Camden Residents' Action Group Incorporated Camden – Still a Country Town

Re: 76 John Street DA 2017/884/1

The design of this proposed additional two-storey building to the rear of 76 John Street as currently presented in the above DA needs to be significantly revised because it is not compliant with the Burra Charter and letter and spirit of state and local planning instruments and policies. Its scale and bulk contravene heritage principles and legislated height requirements for the site and the heritage conservation area (HCA).

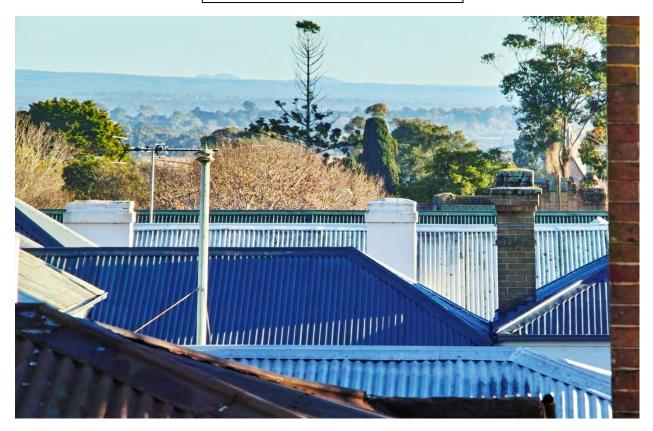
As shown in the photos below the two story building at 64 John Street is out of place and detracts from the streetscape and townscape. Although its form is more in keeping with 19th century architecture than that proposed for 76 John Street, being less squat with a roof pitch seemingly greater than 24°, it is obviously and inappropriately over-height and bluntly incongruous in its context.
